Hearing Identifier: Bellefonte_COL_Public_EX
Email Number: 891

BELLEFONTE COMBINED LICENSE APPLICATION – ITEMS IDENTIFIED IN NRC
HYDROLOGY RELATED SITE VISIT TRIP REPORT

Enclosure
TVA letter dated July 23, 2008
Trip Report Actions

**NRC Hydrology Site Visit Trip Report Action 3
Related to Discussion Items 12 and 25**

Figure 1a: Conceptual Groundwater Pathway #1

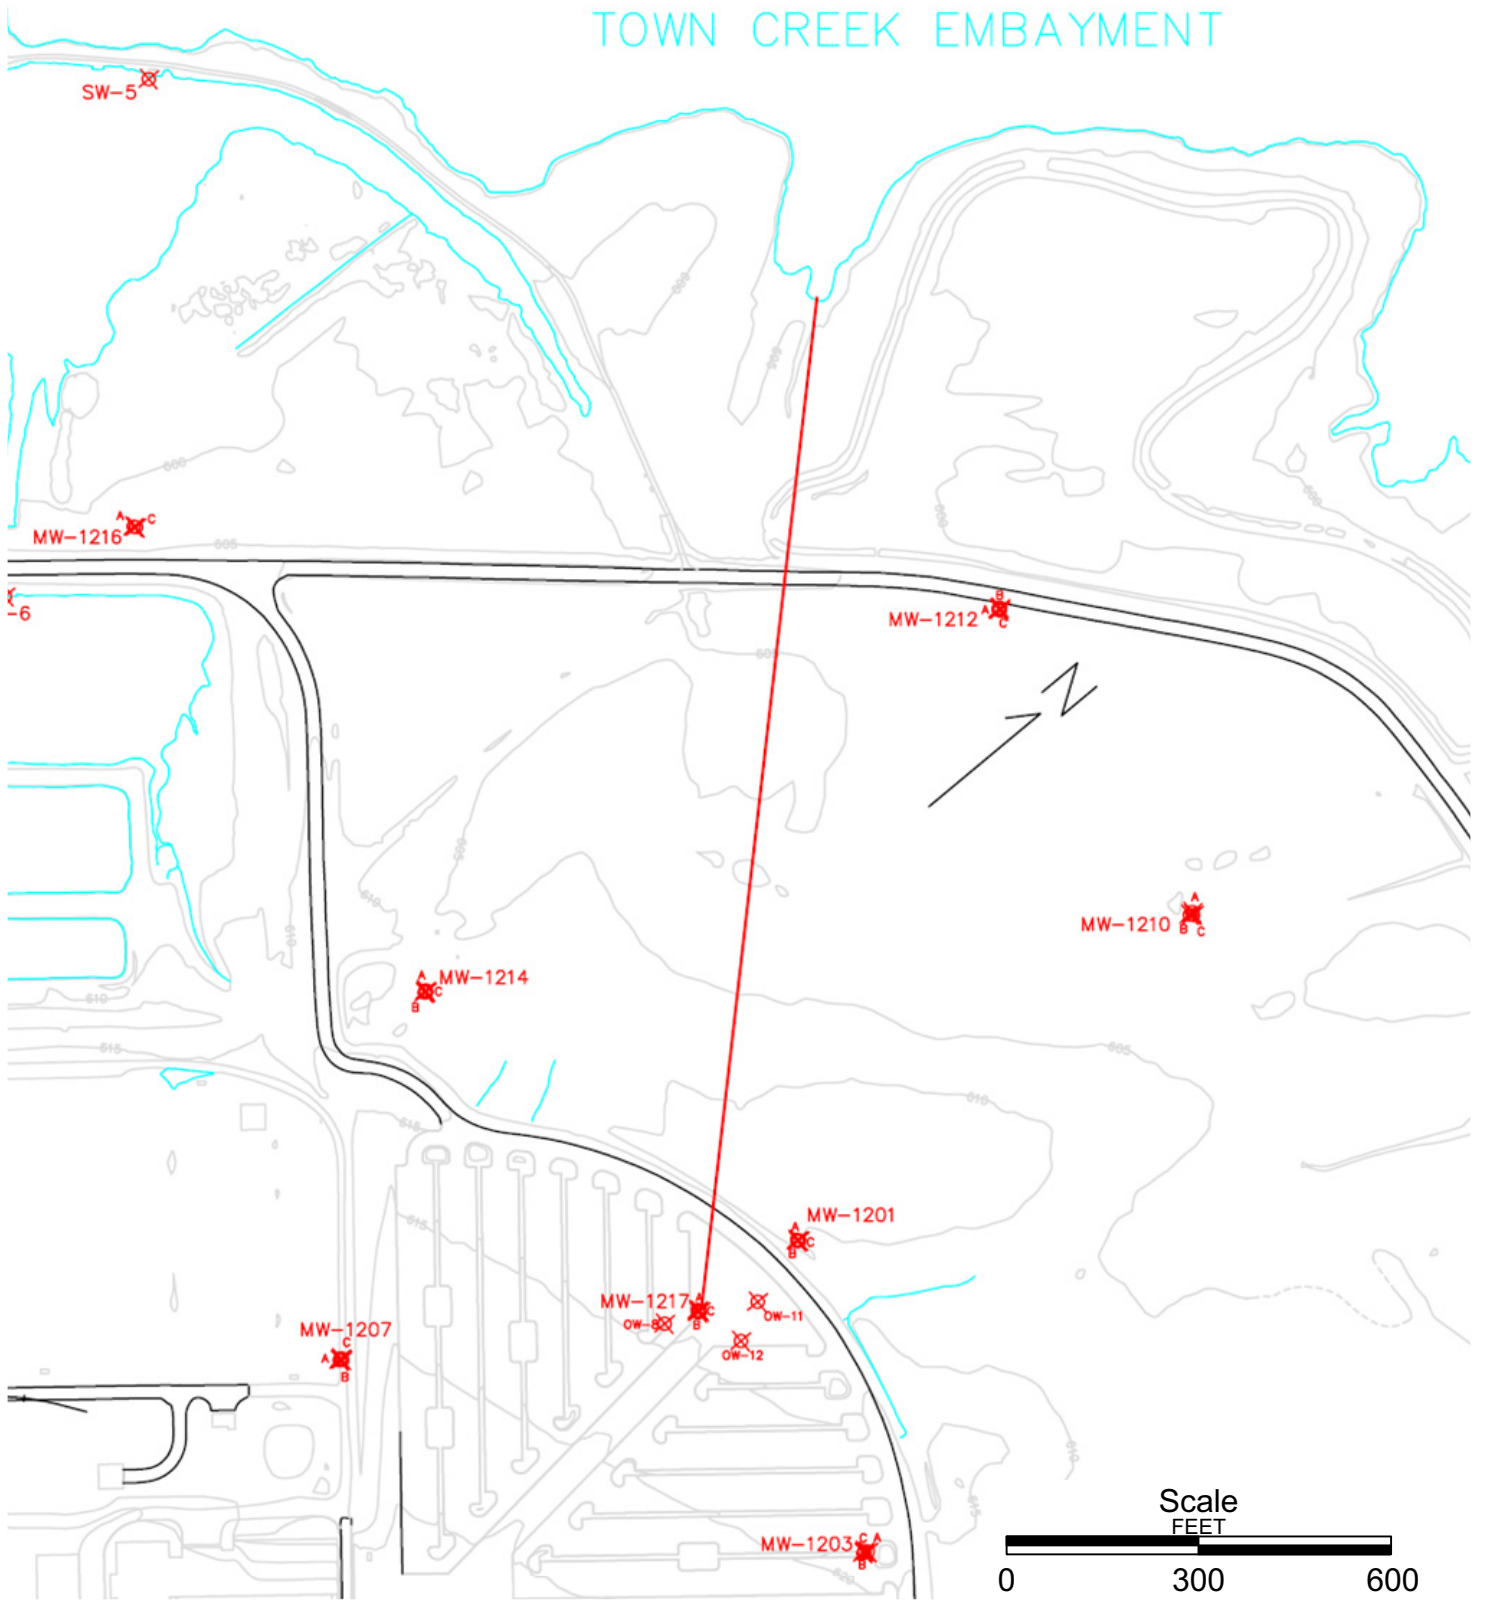
The groundwater velocities for the BLN site have been recalculated using a formation porosity of 0.018 and the B-1046 packer test hydraulic conductivity of 4.2×10^{-3} cm/s with the calculated monthly groundwater velocities (in ft/day) from Unit #3 towards Town Creek (Figure 1a) as follows:

Based on the above findings, the groundwater velocities for the BLN site have been recalculated using a formation porosity of 0.018 and a hydraulic conductivity of 4.2×10^{-3} cm/s. Monthly groundwater velocities from Unit #3 towards Town Creek are presented in Table 1.

Figure 1b: Conceptual Groundwater Pathway #2

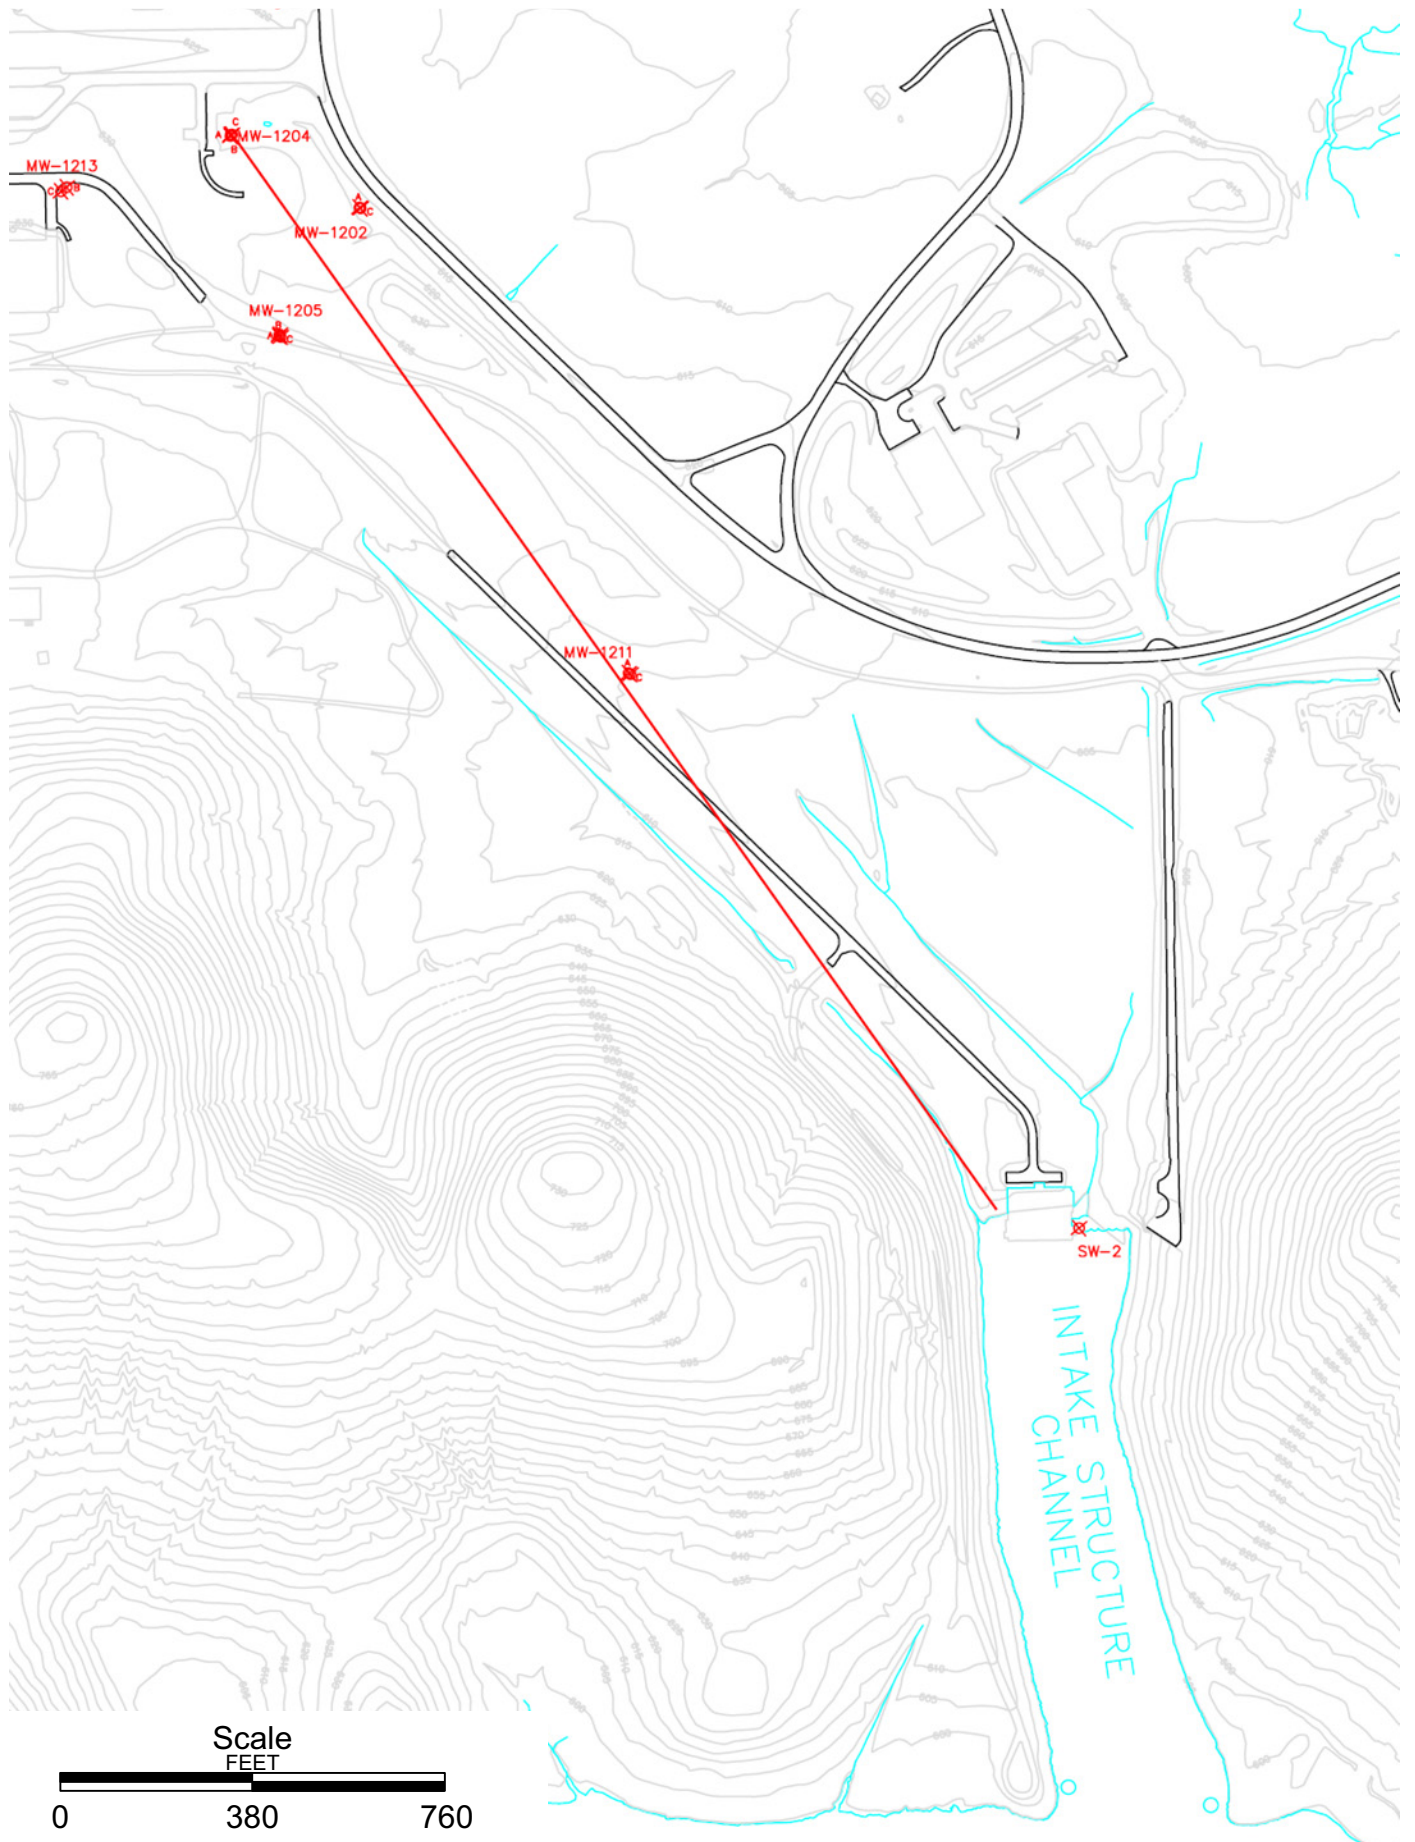
Although the conservative groundwater pathway was assessed from Unit #4 to the Intake Channel (see Figure 1b), this pathway is considered unlikely due to the flow dynamics near the southeast edge of the Unit #4 construction zone and monthly variations in observed groundwater flow gradient direction.

Although the conservative groundwater pathway was assessed from Unit #4 to the Intake Channel (Table 4), this scenario is considered unlikely due to the flow dynamics near the southeast edge of the Unit #4 construction zone and monthly variations in observed groundwater flow gradient direction. Groundwater velocities were determined between MW-1205c and MW-1211c (Table
